REQUEST – August 14, 2020

(PUD2003) Wesco Inc. (36th Ave./Baldwin PUD), is requesting preliminary (for this parcel only since the preliminary approval has expired and the rest of the site has already been developed) and final planned unit development approval for a vehicle service station and convenience store on P.P. # 70-14-17-100-024, located at 7661 36th Ave., Georgetown Township, Ottawa County, Michigan. (NO public hearing)

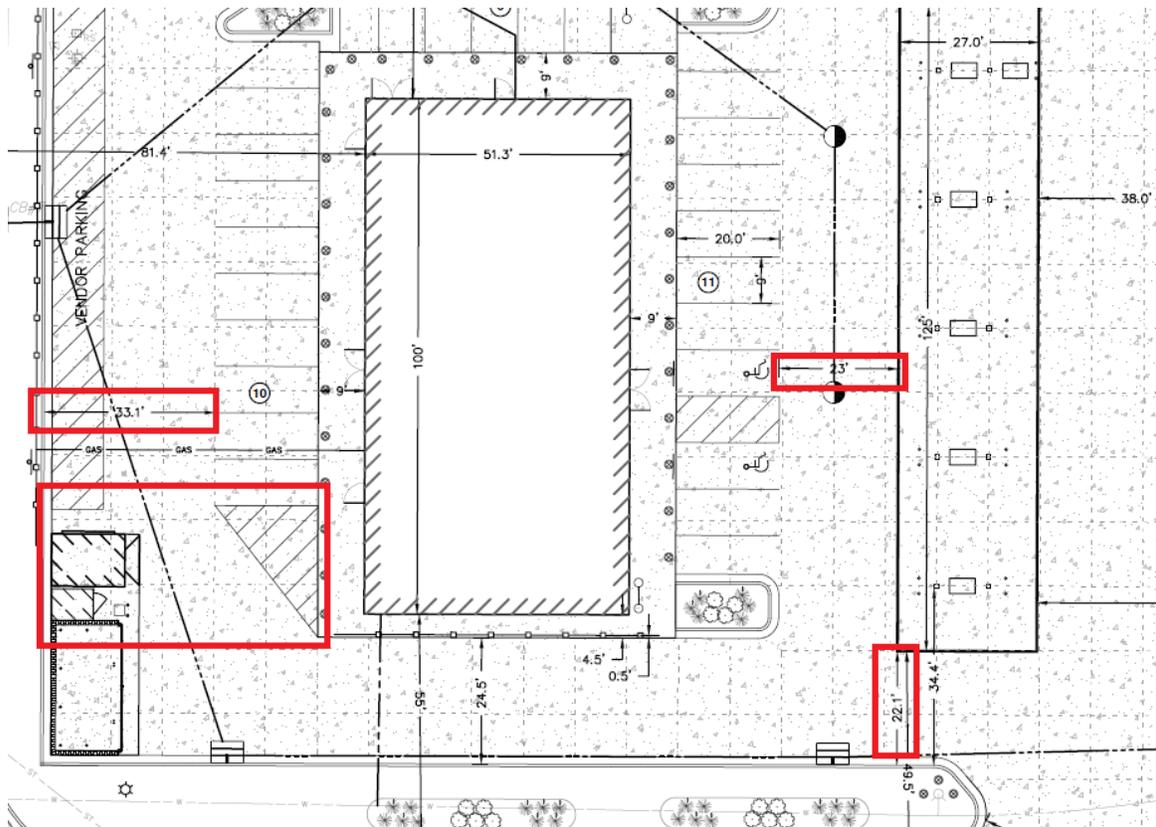
- e. **A deviation request is also noted for the drive aisles. Three locations on the site do not meet the 24 foot drive aisle requirement for two way traffic. Note, if these dimensions are not acceptable, direction could be given for them to be widened and administratively approved.**

- 1) **On the west side of the building, 31 feet is noted from the edge of the parking spaces to the western curb. However, there is a choke point where the aisle narrows between the parking spaces which looks to be significantly less than the minimum required 24 feet.**

- 2) **On the south side of the canopy, the distance from the canopy to the curbed area is only 22 feet and the applicant is requesting deviation approval for the area under the canopy to be counted toward that 24 foot requirement. However, consider that there may not be room if a vehicle is at the southern-most gas dispenser.**

- 3) **On the east side of the building between the end of the parking spaces and the canopy is only 23 feet. Again, a vehicle could be parked at the dispenser and prevent the two way traffic.**

- e. **Should the plan be redrawn for the drive aisle widths? Or are any acceptable? If a redrawing is necessary, could it be administratively approved?**

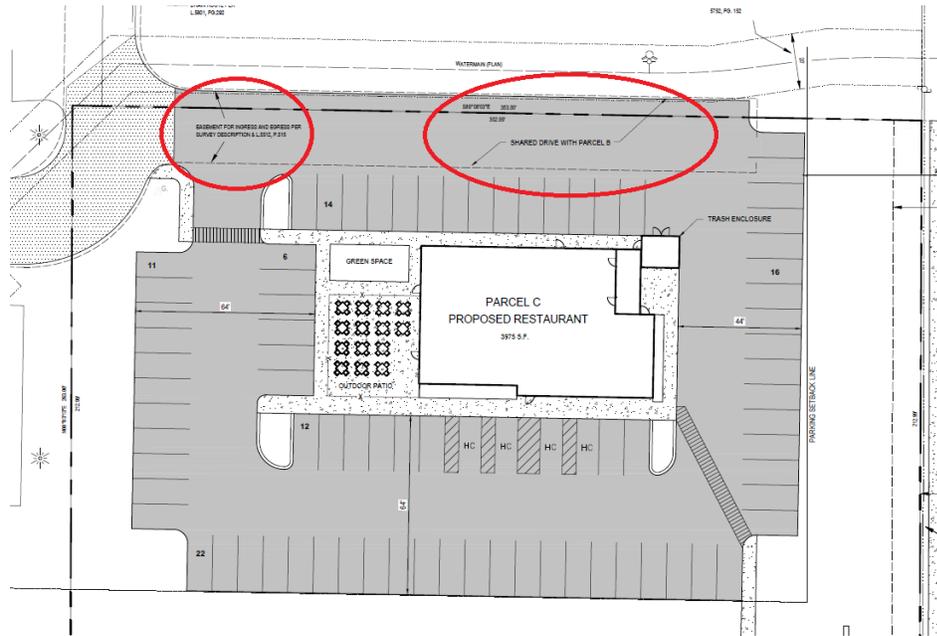
Appears to be met. An eight-foot wide bike/pedestrian pathway is proposed along 36th Ave. and a walking path is proposed from the store to Black Star St.
